CERTIFICATE OF APPROPRIATENESS

Property: 1031 Le Green Street, Lot 13, Block 110, North Norhill Subdivision. The property includes a historic 1,190 square foot one-story wood frame single-family residence and detached garage situated on a 5,000 square foot interior lot.

Proposal: Alteration – Revision. Alter the fenestration of the existing south (front) and east elevations of the historic residence. The removal of the single original windows and installation of new wood paired windows on the front elevation, as well as the removal of a side window and installation of a smaller slider window, was denied at the July 2015 HAHC meeting. The applicant now proposes the following work:

Recommendation: Denial - does not satisfy criteria 1, 4, 7, 8, 9

SOUTH ELEVATION – FRONT FACING LE GREEN STREET

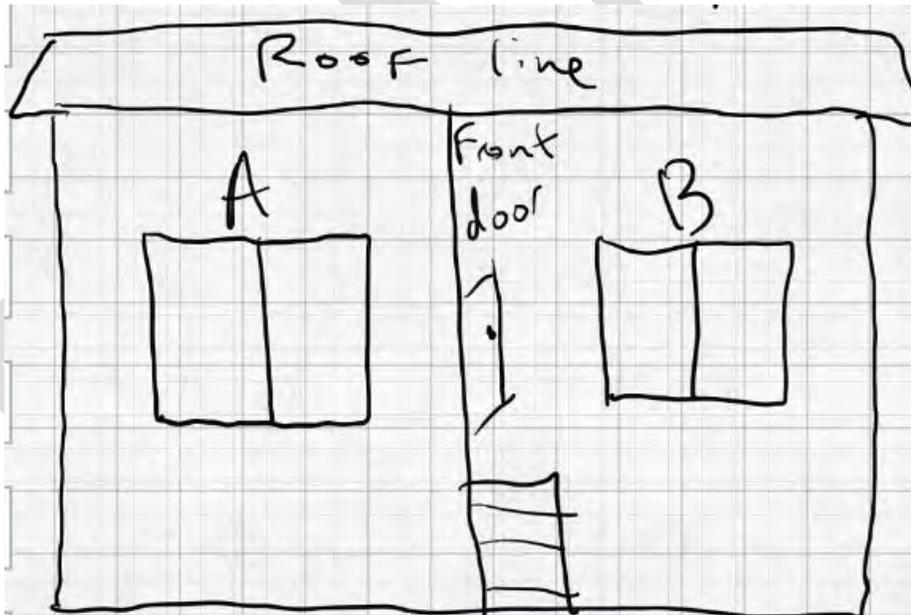
<i>The removal of the original windows, trim, and siding as well as the addition of paired windows to the façade of this building is highly visible and represents a failure to retain and preserve the historical character of the property.</i> |

<i>A single window located in each of the two front bays was a highly visible and distinguishing characteristic of this residence. No evidence has been submitted supporting that this residence originally had paired windows on the front elevation. Adding additional fenestration to the façade of this building is highly visible and alters its original historic appearance.</i> |

<i>No evidence has been submitted supporting that this residence originally had paired windows on the front elevation. Adding additional fenestration to the façade of this building is a highly visible and invasive alteration to its original historic appearance.</i> |

EAST SIDE ELEVATION

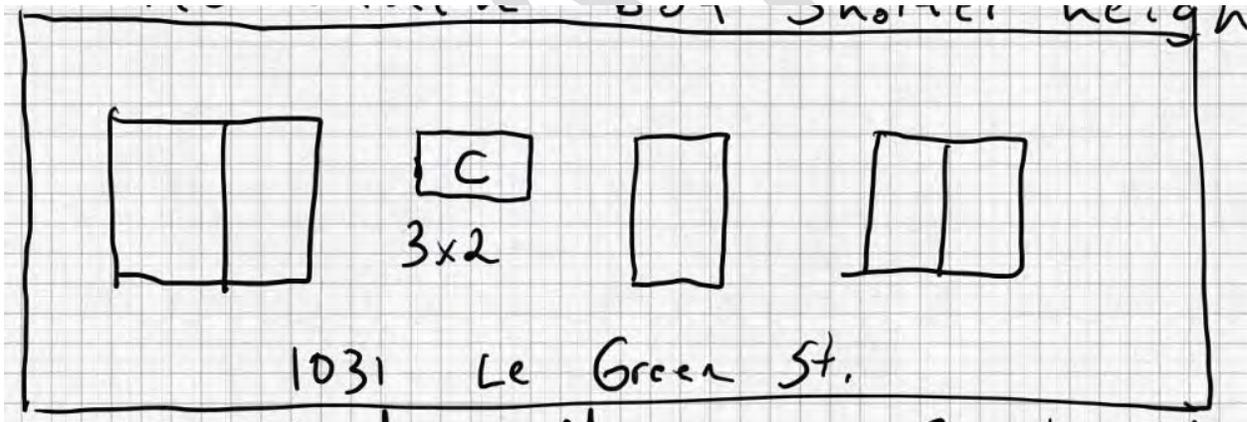
<i>The removal of existing historic windows, the expansion and alteration of the original window openings and the addition of paired windows on the façade and a smaller window on the east elevation impairs the integrity of the historic structure. Additionally, the shifting of windows is extremely invasive. As this is a balloon framed house, the walls will have to be reframed and headers installed to allow for proper installation of the new windows.</i> |
